APPLICATION NO: 19/00088/FUL	OFFICER: Miss Claire Donnelly
DATE REGISTERED: 17th January 2019	DATE OF EXPIRY : 14th March 2019
WARD: Park	PARISH:
APPLICANT:	Dr & Mrs Saha
LOCATION:	16 Rowena Cade Avenue, Cheltenham
PROPOSAL:	Single storey rear extension and alterations to front and rear elevations to include Juliette balconies

ADDITIONAL REPRESENTATIONS

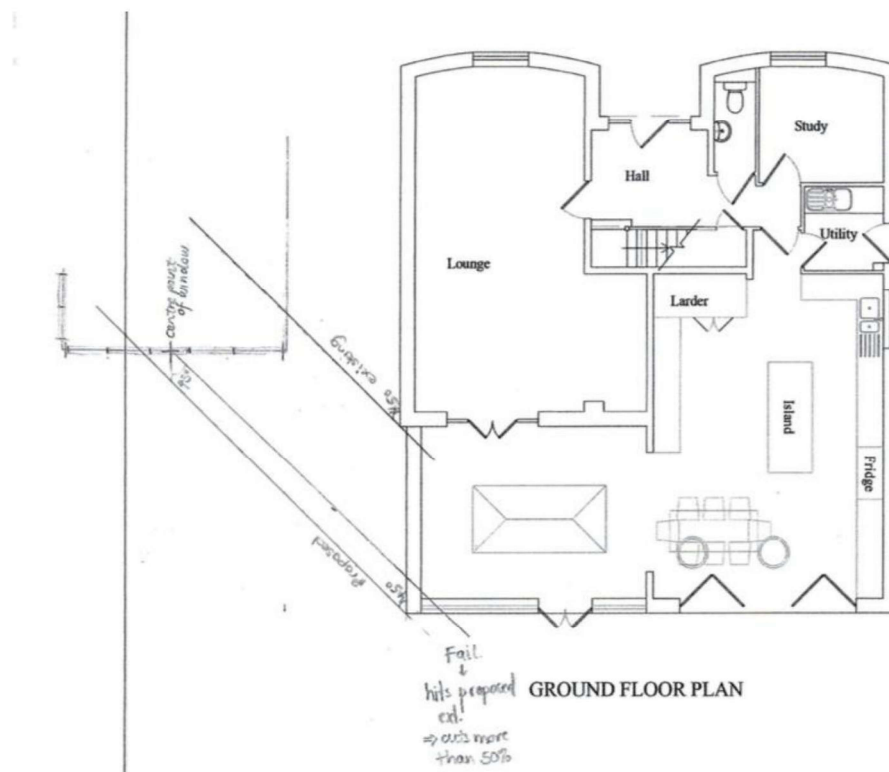
We do however remain concerned about the depth of the extension, at 4.2m on our side.

The property at number 16 is set back further from the road than our own home and already results in the rear of our home losing light, sunlight and being overshadowed, particularly to our lounge and patio, during the day. In an attempt to compensate for this we added large glass sliding doors to our lounge to maximize light into these areas, and also to allow light to flow through to the patio, dining room and kitchen.

With reference to paragraph 6.17 of the Officers report, we believe that due to the orientation of our home and garden (WNW facing) means that should this application be allowed at the 4.2m depth proposed, we will suffer even more from an increased loss of light, sunlight and additional overshadowing to our lounge and dining room.

In addition although a light test has been conducted we have been advised by the planning office that the proposal fails on one of the tests, which unfortunately will impact on these rooms; the main living areas of our home. A copy of the drawing, annotated to show the existing and proposed effect, is below.

We believe that just a small reduction in the depth on this elevation would redress this issue and mean that we would enjoy the same amenity as we do now, whilst still allowing our neighbours an extension to meet their wishes.
